CITY OF ALBUQUERQUE

**Re: Sunrise Ranch West Subdivision
Analysis for 106th St SW
Drainage Report, Engineer's Stamp Date 3-24-2015 (File: L08D14)**

DRAINAGE AND TRANSPORTATION INFORMATION SHEET

DRAINAGE REPORT
For
Sunrise Ranch West Subdivision

**Figure 6 Onsite Detention Pond
Outfall Structure**

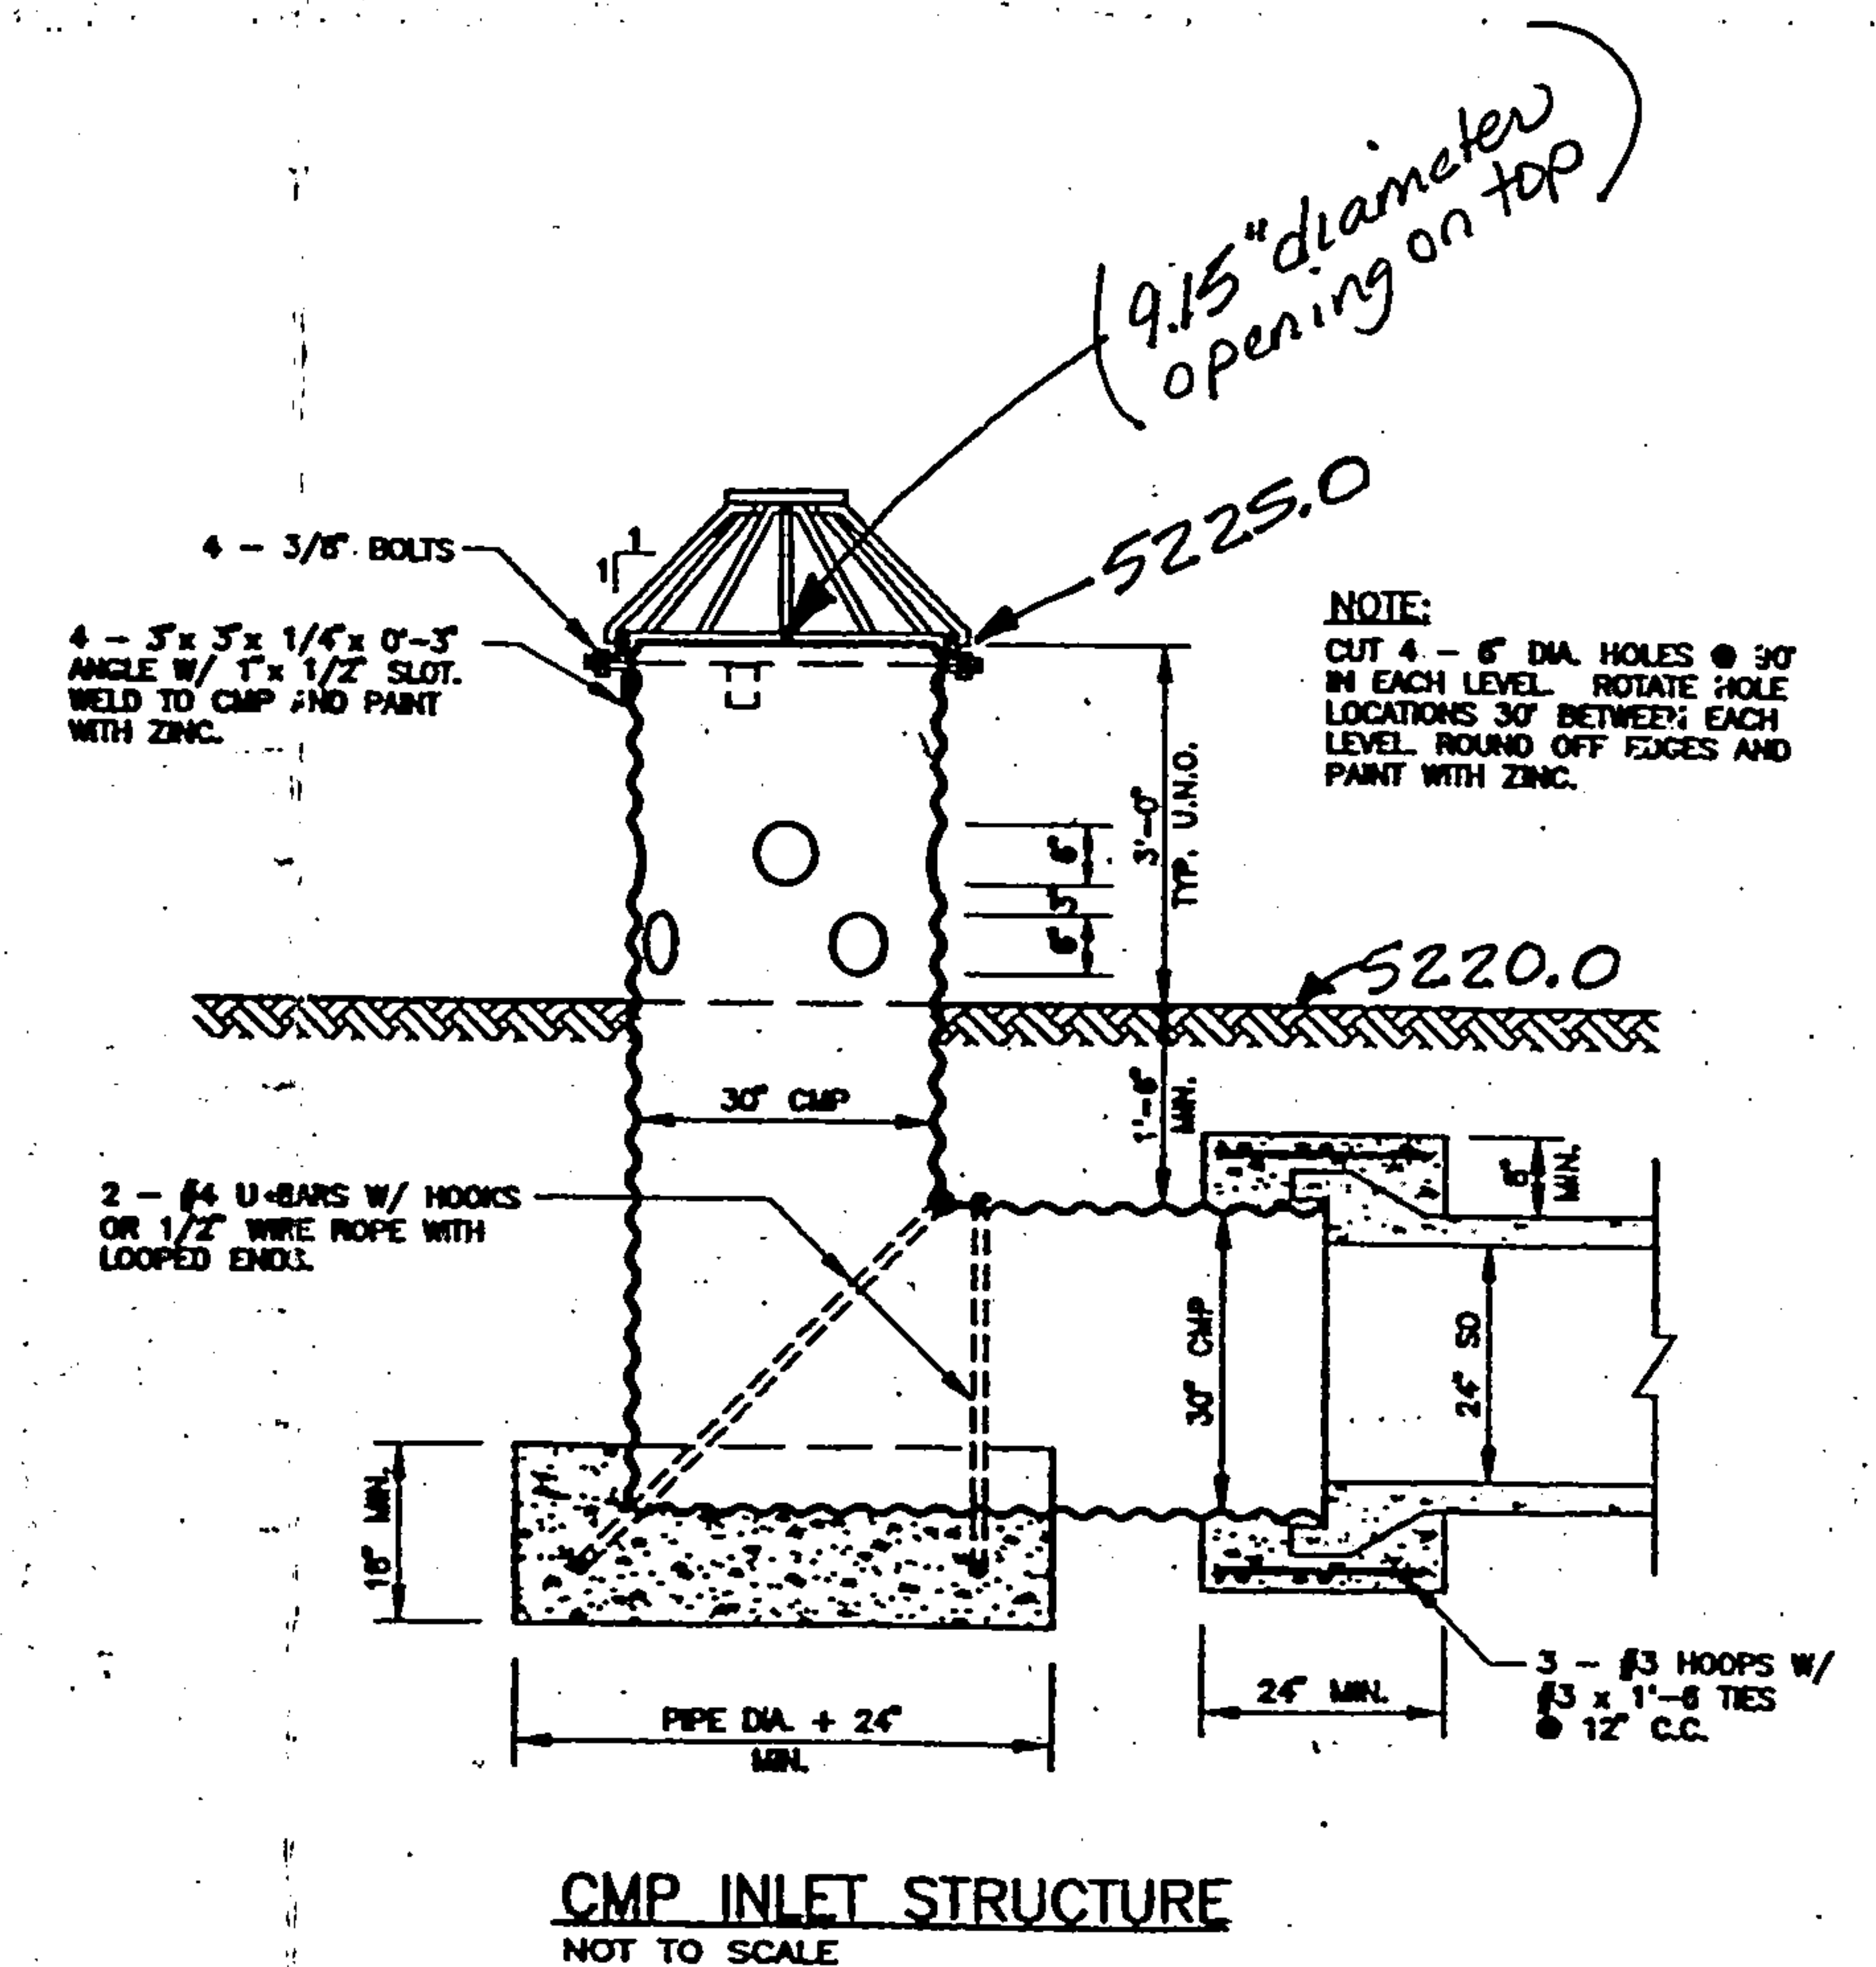
- Increasing the size of the outlet pipe from the pond in Basin 160 is not the ultimate condition for this basin. *correct it's interim* It is wiser to increase the size of the pond than increase the pipe, and then install a smaller pipe upon later development (in order to detain the basin to acceptable levels). *will require increase in report, not possible*

8. Design grades for the backyards of Sunrise Ranch Unit 2 have been added to the G&D plan.
9. To increase the size of the pond would require the limits of the temporary drainage easement to increase. I doubt that the current property owners would agree to this. Since the allowable discharge to the Snow Vista Pond from this existing offsite pond is much greater than the current design discharge from the outfall structure, adjusting the existing outfall structure to allow an increase in discharge is the best solution for the interim condition. When the site west of 106th street develops, the storm sewer can remain and an orifice plate constructed to restrict the "developed conditions" runoff to the allowable discharge.
